P ~~28201~~
A REPAIR

SEWAGE DISPOSAL SYSTEM

MARYLAND STATE DEPARTMENT OF HEALTH*

SUBDIVISION _____ ROAD 2486 Daisy Road LOT _____

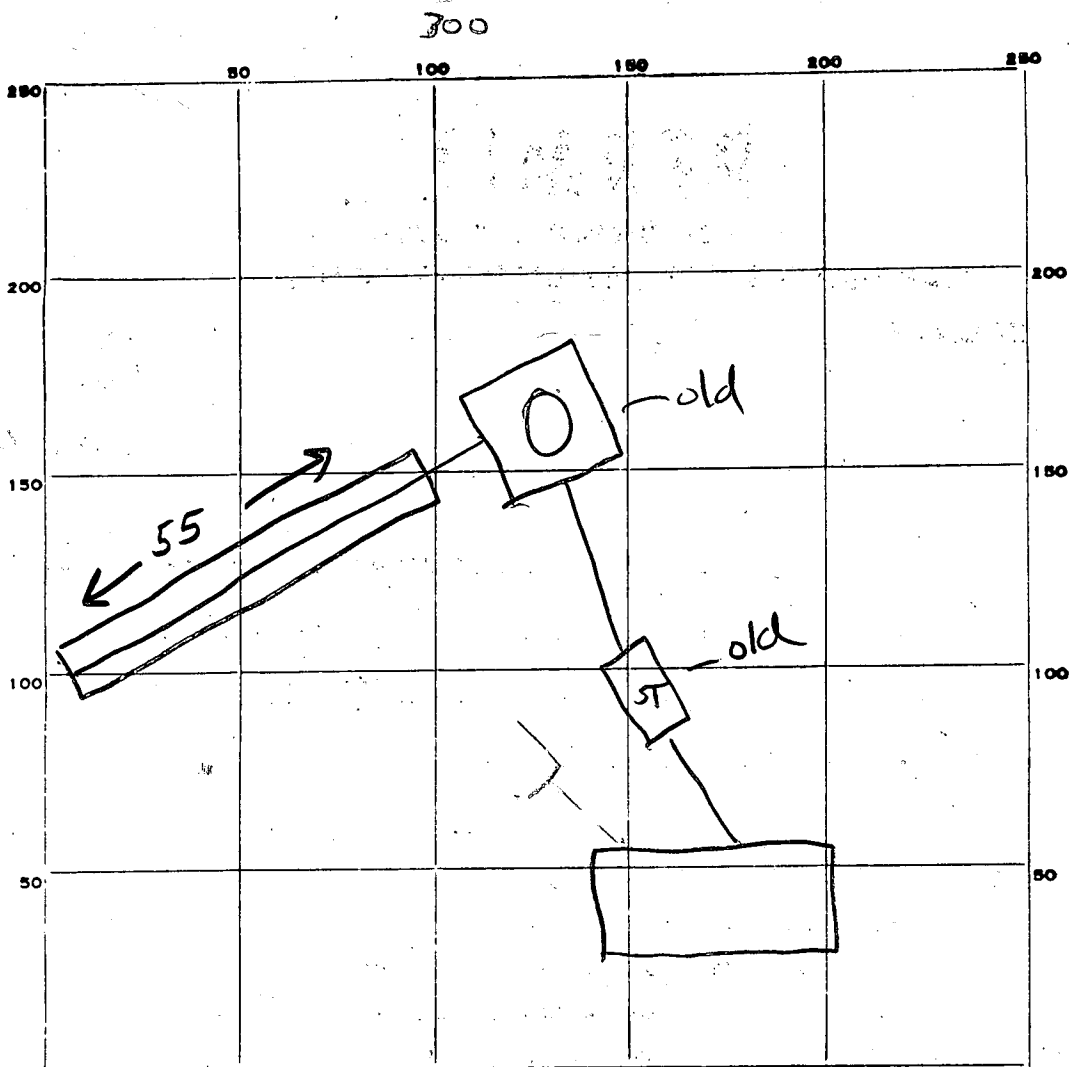
REPAIR-CALL FOR INSPECTION WHEN GROUND IS OPENED UP SO SANITARIAN CAN RECOMMEND

REPAIR. 55ft trench running with contour 12ft deep with 8 ft of stone with inlet at 4'. GLK 26 July 78
